NORTHERN WOLVES
AIR CONDITIONING

Ref. Quote: 3112 / Date: 10/6/2026 / Rev 0

Project: **Sunrise Rye Brook - 900 King St, Rye Brook, NY 10573**

Value Engineering Mark-ups - VAV zoning, cabinet heaters, basement fan coils

SHEET TITLE
**INDEPENDENT LIVING
FIRST FLOOR PLAN -
MECHANICAL IL AREA**

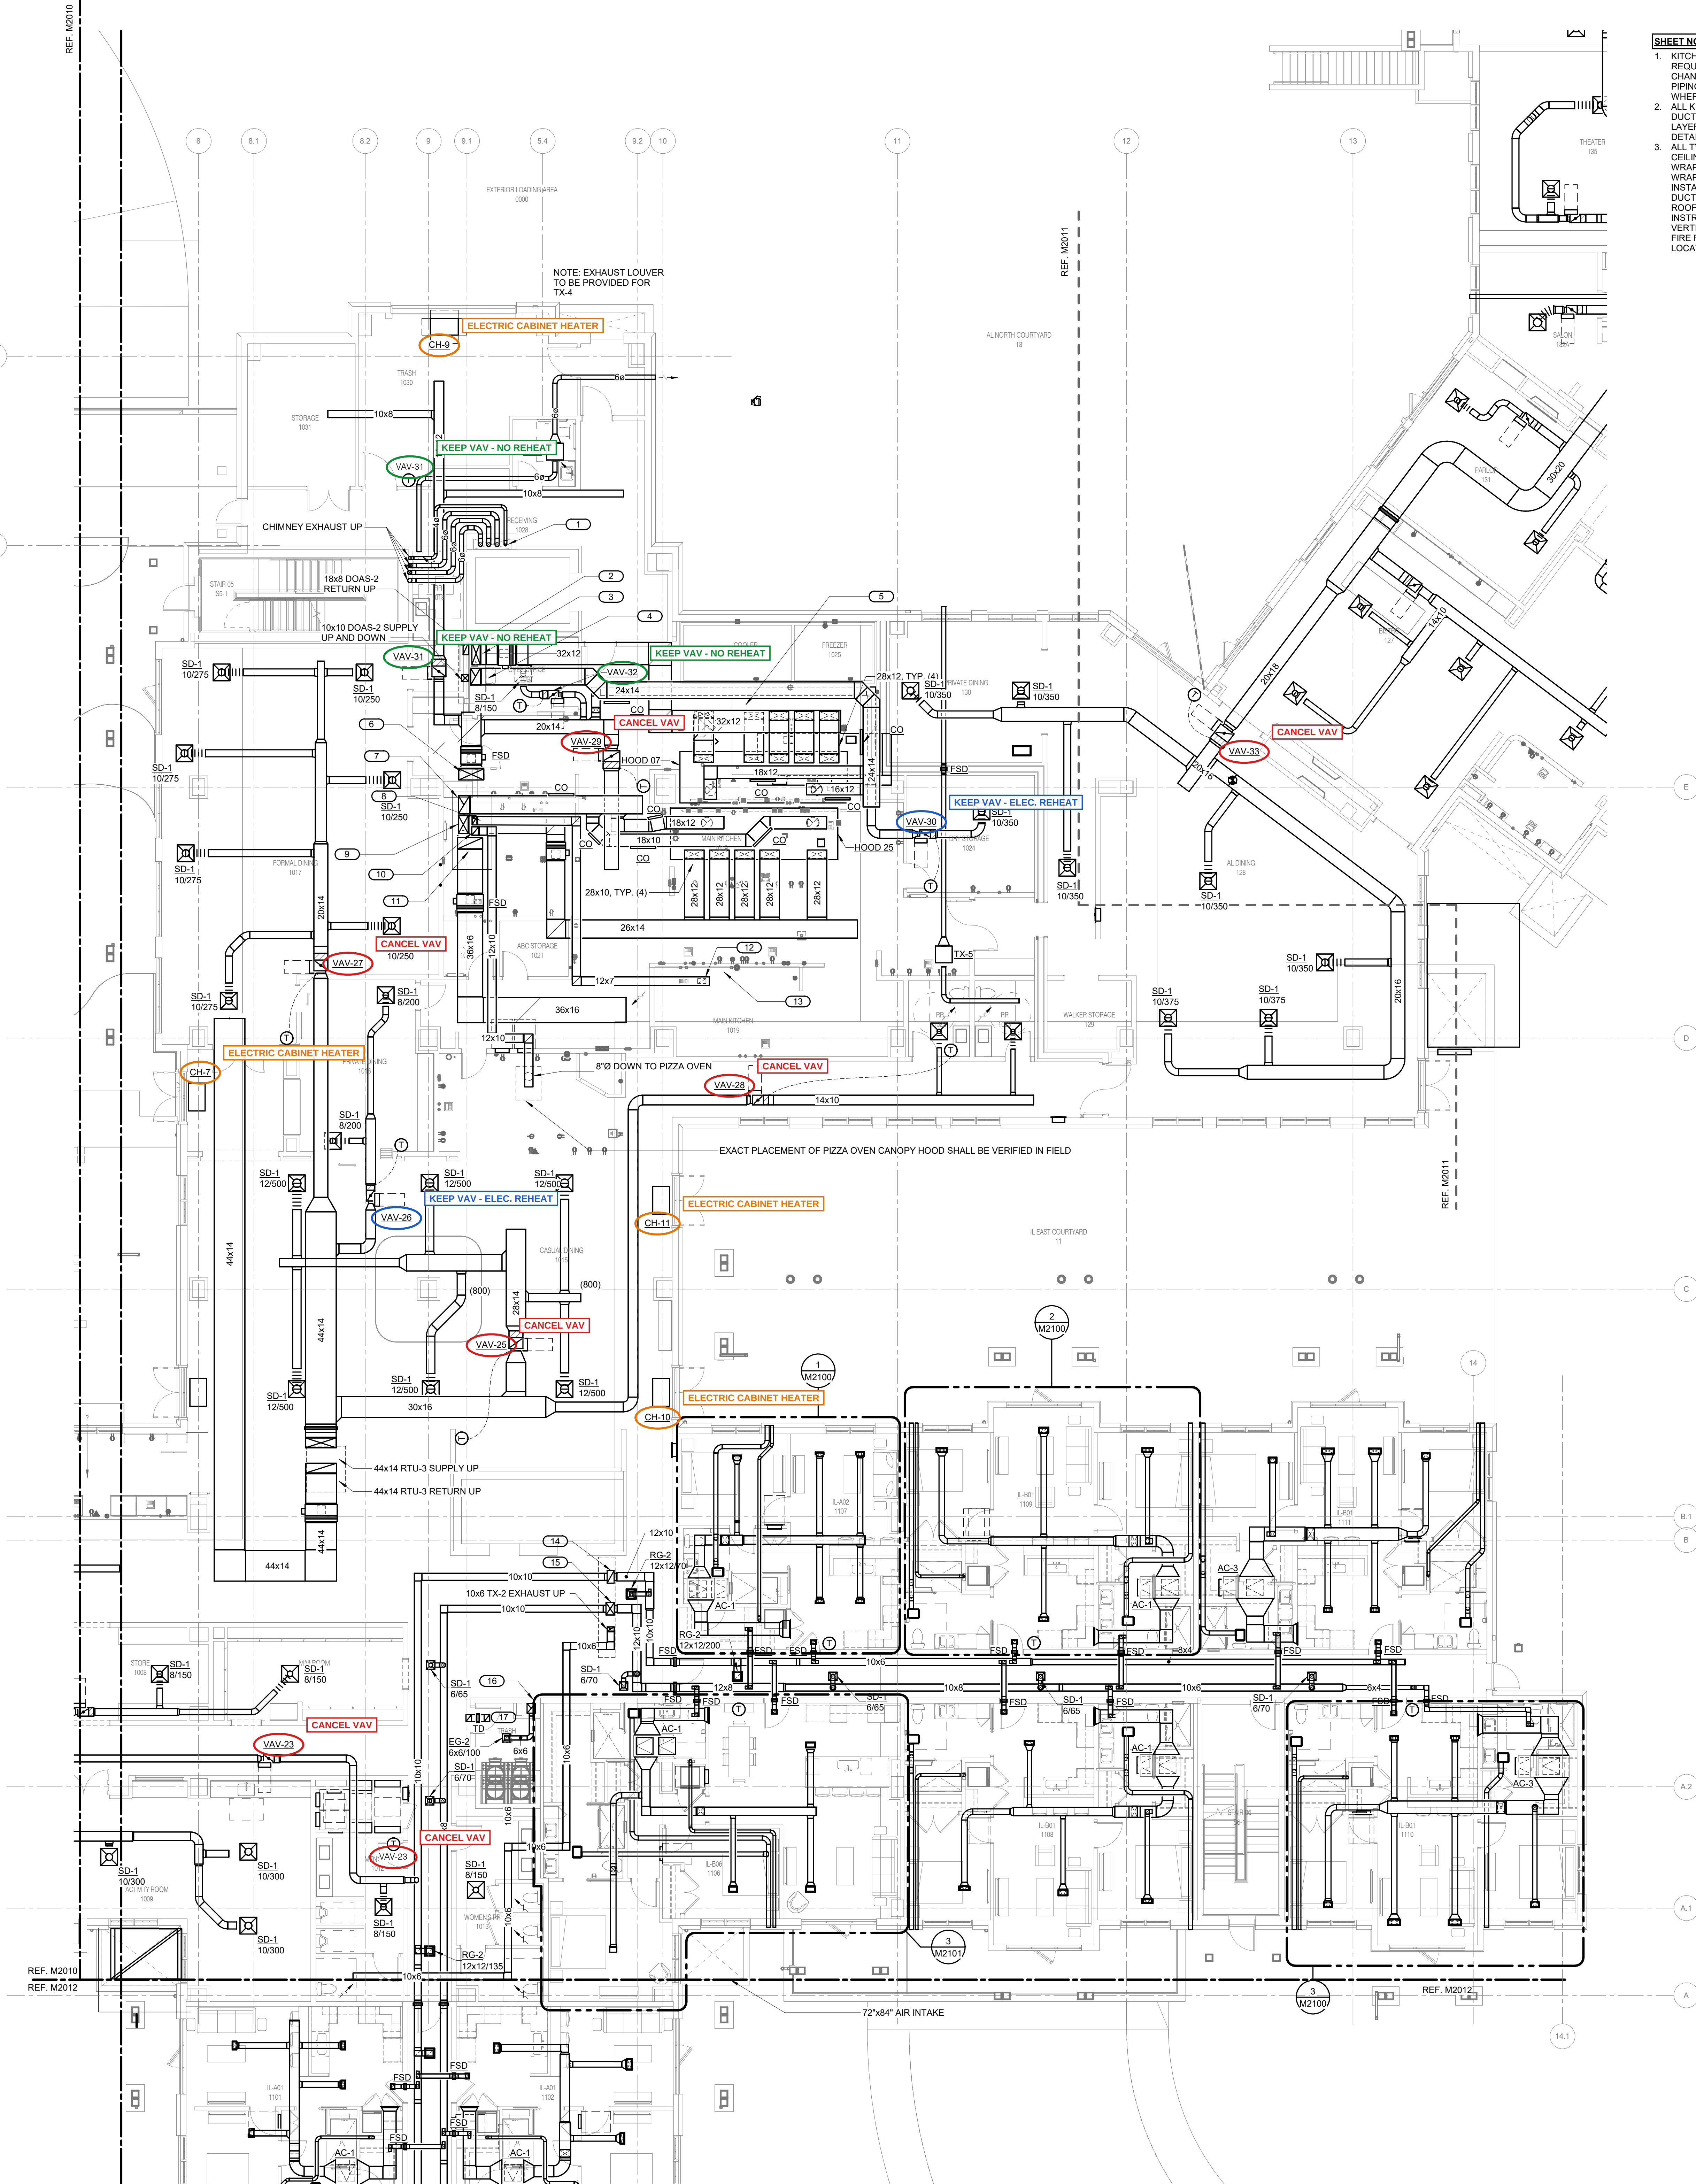
Sheet	VAV	Room / area served	Note	Proposal
M2010	VAV-1	Movement Studio 1045		KEEP VAV - ELEC. REHEAT
M2010	VAV-2	Fitness 1044		KEEP VAV - ELEC. REHEAT
M2010	VAV-3	Multi-Purpose Room 1043		KEEP VAV - ELEC. REHEAT
M2010	VAV-4	Theater 1042		KEEP VAV - ELEC. REHEAT
M2010	VAV-5	Corridor / gallery		CANCEL VAV
M2010	VAV-6	Corridor		CANCEL VAV
M2010	VAV-7	Spa / Salon 1041A		KEEP VAV - ELEC. REHEAT
M2010	VAV-8	IT Office 1036 / AV Closet		KEEP VAV - NO REHEAT
M2010	VAV-9	Gen. Manager Office 1035		KEEP VAV - ELEC. REHEAT
M2010	VAV-10	Locker rooms / sauna (pool area)	Pool / sauna by others - not marked	NO CHANGE
M2010	VAV-11	Art 1032		KEEP VAV - ELEC. REHEAT
M2010	VAV-12	Lounge 1004A		CANCEL VAV
M2010	VAV-13	Lounge / Bistro 1004A-B		CANCEL VAV
M2010	VAV-14	Security 1033 / Package 1003B		KEEP VAV - NO REHEAT
M2010	VAV-15	AVC 1034B		KEEP VAV - ELEC. REHEAT
M2010	VAV-16	Sales Office 1034C		KEEP VAV - ELEC. REHEAT
M2010	VAV-17	Family Meeting Room 1002		KEEP VAV - ELEC. REHEAT

M2010	VAV-18	Reception 1003A		CANCEL VAV
M2010	VAV-18	Treatment Rm 1041C	Tag duplicated on drawing - clarify	KEEP VAV - ELEC. REHEAT
M2010	VAV-19	Coffee Shop 1006		CANCEL VAV
M2010	VAV-20	Library 1007		KEEP VAV - ELEC. REHEAT

Sheet	VAV	Room / area served	Note	Proposal
M2010	VAV-21	Store 1008		KEEP VAV - ELEC. REHEAT
M2010	VAV-22	Activity Room 1009		KEEP VAV - ELEC. REHEAT
M2010	VAV-24	Bistro 1004B		CANCEL VAV
M2011	VAV-23	Restrooms 1012-1013 / Mailroom		CANCEL VAV
M2011	VAV-25	Casual Dining 1015		CANCEL VAV
M2011	VAV-26	Private Dining 1016		KEEP VAV - ELEC. REHEAT
M2011	VAV-27	Formal Dining 1017		CANCEL VAV
M2011	VAV-28	Restrooms / kitchen corridor		CANCEL VAV
M2011	VAV-29	Main Kitchen 1019		CANCEL VAV
M2011	VAV-30	Private Dining 130 / Dry Storage		KEEP VAV - ELEC. REHEAT
M2011	VAV-31	Storage 1031 / Trash 1030 / Receiving		KEEP VAV - NO REHEAT
M2011	VAV-32	Chef Office 1027		KEEP VAV - NO REHEAT
M2011	VAV-33	AL Dining 128		CANCEL VAV
M2013	VAV-34	Bistro 127		CANCEL VAV
M2013	VAV-35	Bistro / dining 127		CANCEL VAV
M2013	VAV-36	Parlor 131		CANCEL VAV
M2013	VAV-37	Reception 126		CANCEL VAV
M2013	VAV-38	Family Room 120		KEEP VAV - ELEC. REHEAT

Sheet	Tag	Location	Electric (approx.)	Proposal
M2010	CH-1	Movement Studio entry	5.3 kW	ELECTRIC CABINET HEATER
M2010	CH-3	Pool deck / stair entry	5.3 kW	ELECTRIC CABINET HEATER
M2010	CH-4	Exterior door at gallery	5.3 kW	ELECTRIC CABINET HEATER
M2010	CH-5	Fitness entry	5.3 kW	ELECTRIC CABINET HEATER
M2010	CH-12	Multi-Purpose Room entry	5.3 kW	ELECTRIC CABINET HEATER
M2010	CH-6	Vestibule 1001	5.3 kW	ELECTRIC CABINET HEATER
M2011	CH-7	Formal Dining entry	5.3 kW	ELECTRIC CABINET HEATER
M2011	CH-9	Trash 1030 / Storage	10.4 kW	ELECTRIC CABINET HEATER
M2011	CH-10	Casual Dining entry	5.3 kW	ELECTRIC CABINET HEATER
M2011	CH-11	Casual Dining entry	5.3 kW	ELECTRIC CABINET HEATER
